PAGE REPLACEMENT GUIDE FOR
AMENDMENT 70
CLINCH RIVER BREEDER REACTOR PLANT
PRELIMINARY SAFETY ANALYSIS REPORT

(DOCKET NO. 50-537)

Transmitted herein is Amendment 70 to Clinch River Breeder Reactor Plant Preliminary Safety Analysis Report, Docket 50-537. Amendment 70 consists of new and replacement pages for the PSAR text and Responses to NRC Questions.

FIGURE Q220.39-5 COEFFICIENT OF THERMAL EXPANSION -
VERIFICATION PROBLEM

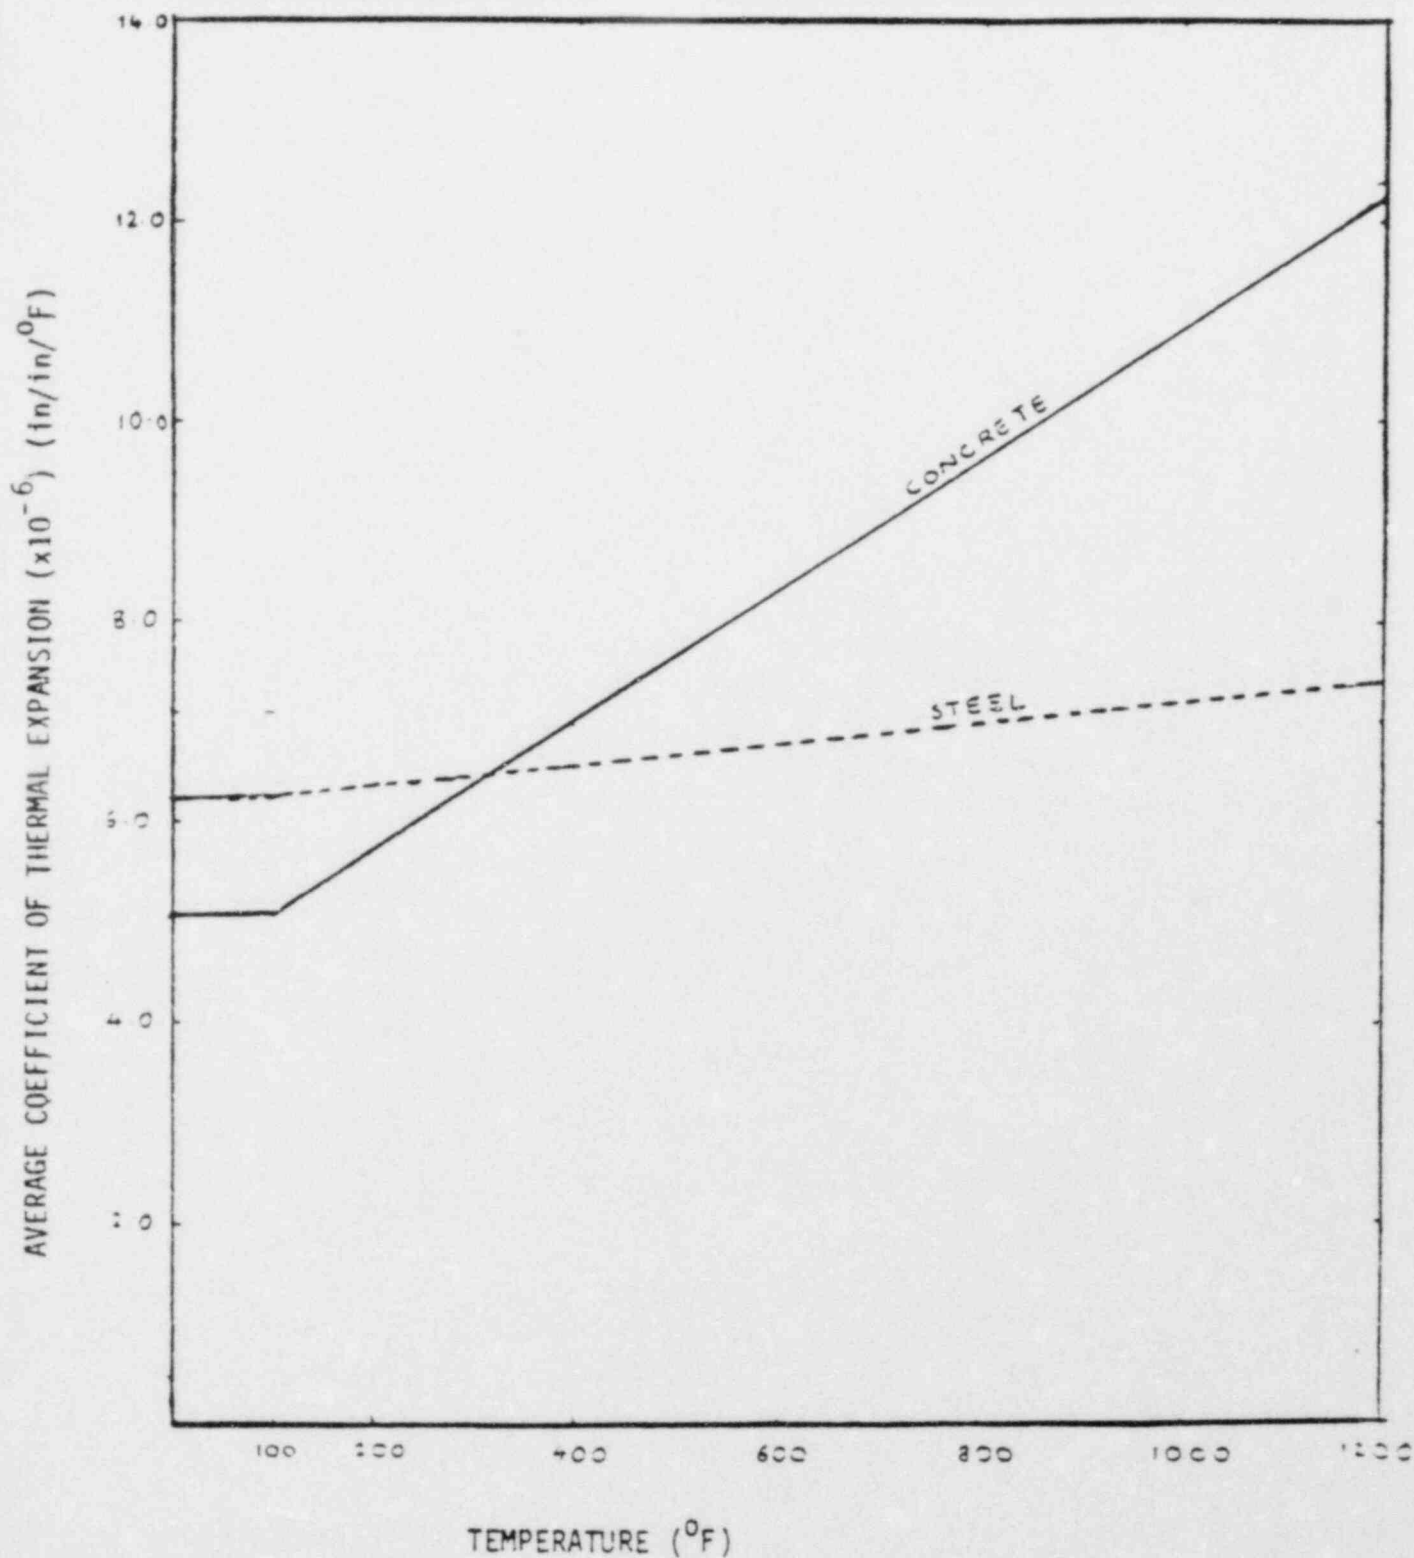
The applicant has provided information showing that such section failure do not occur before TMBDB requirements are met. Additional details should be provided to show how close these internal structures come to failure as the TMBDB scenario progresses. Rates at which failure is approached and times that failure is expected should also be provided. This should be done for all critical sections. This is particularly important because no factor of safety is applied to the section failure capacities.

Critical sections in the RCB structures have been or are being evaluated for rates of failure progression and expected failure times.

In accordance with the TMBDB scenario described in CRBRP 3, Vol. 2 the Reactor Cavity and the three Pipeway Cells are the only cells in the Reactor Containment Building that would be exposed to sodium. The base case scenario considers failure of the liner to occur at certain times and these failure times establish the minimum structural integrity requirements for the liner system. Since the liner system is anchored to concrete structures, failure of these structures (sectional capacity exceeded) is considered, conservatively, to imply potential liner failure so that the minimum times for structural integrity requirements for the liner apply also to the supporting concrete.
